Technical change for the ZDU 2.5/4AN feed through terminal block

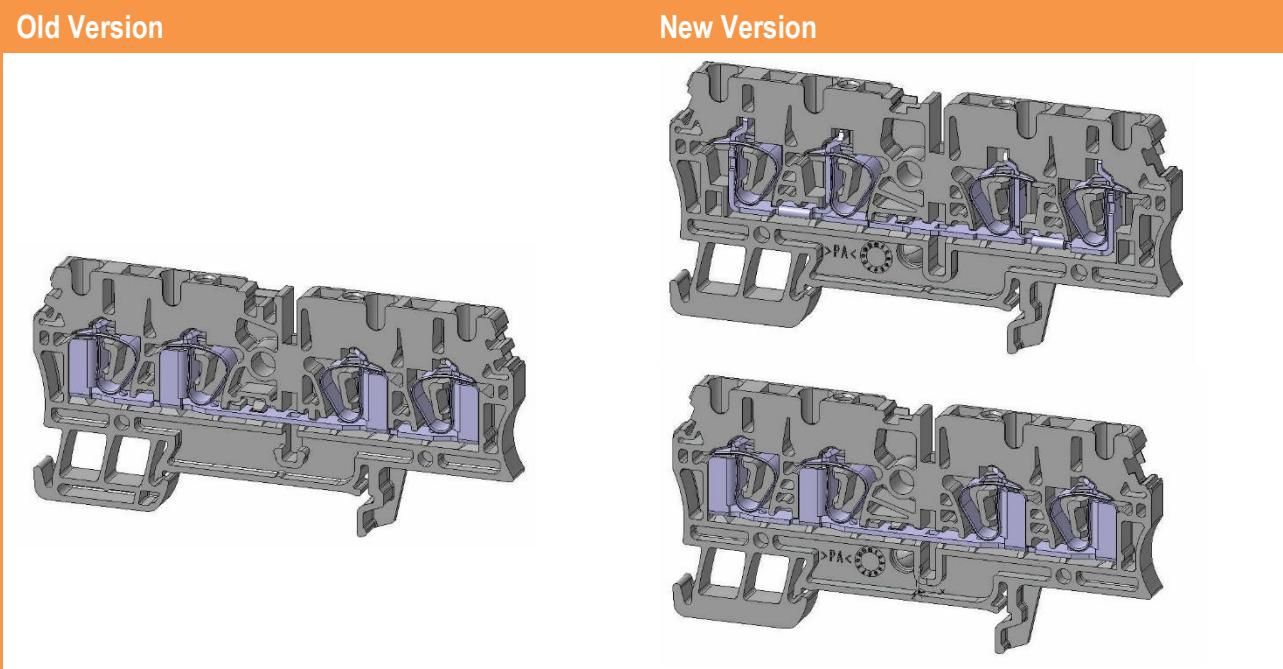
The current bars of the ZDU 2.5/4AN terminal block have lateral lugs on each connection which close the terminal connection space of the terminal block.

The lugs of the terminals have been removed as part of the product optimization. The removal of these lugs has no effect on the technical properties of the terminal block.

In addition, the marking channel has been optimized. The marking channel now has a slip-off protection on both sides, which prevents markers from slipping out of the side of the terminal block.
